# 18-067ARB-MPR – DUBLIN TOY EMPORIUM SIGN

Minor Project Review for an existing sign for a tenant located within Historic Dublin.

Approval Minor Project Review with 3 conditions.

2) **Details**

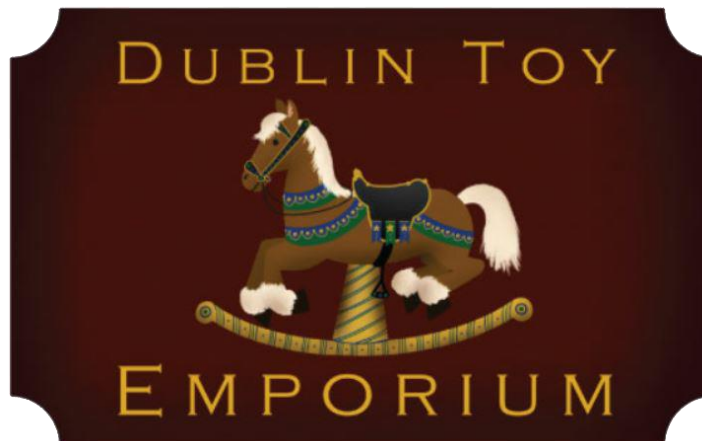
The Code permits projecting signs within the Historic District to be a maximum of 8 square feet in size. A projecting sign approximately half the permitted size is requested with this application. The sign is affixed to an existing wrought iron bracket, which the applicant has indicated is mounted to allow for 8 feet of clear distance below the sign. The applicant will need submit verification to the Building Standards Division confirming the clear distance below the sign prior to the issuance of a sign permit. Additionally, all mounting hardware should be painted to match the mounting bracket.

Code requires signs to be limited to three colors; however, a logo with multiple colors may count as one of the three colors permitted. The proposed sign includes three colors: brown for the background, goldenrod for the letters, and multi-color for the logo.

The proposed sign panel is a double-faced, 0.5-inch MDO (Medium Density Overlay) plywood sign, which is not a permitted material in the Code. The sign will need to be revised to incorporate an approved material of High Density Urethane (HDU), cedar, redwood, treated lumber, and equivalent materials, as required by Code. The graphic is printed on 3M ControlTac with a UV laminate coating and is subsequently affixed to the MDO.

The Historic Dublin Design Guidelines encourage signs to be fabricated of a high-quality, durable material; and to be finished with paint or carving. The majority of the signs approved throughout the District include a dimensional element. Staff has determined the graphic design of the sign creates the sense of dimension; although, notes this sign is different from what the Board has approved in the past. Staff attributes the material selection and dimensional appearance to advancements in graphic design and printing making it quicker and more affordable to make signs than ever before.

- 1) That the applicant use a permitted wood material for the sign background (HDU, cedar, redwood, treated lumber, or equivalent material);
- 2) That the applicant demonstrate eight feet of clear area is provided beneath the sign to be verified by the Building Standards Division at sign permitting; and,
- 3) The sign mounting hardware be painted to match the color of the hanging bracket.
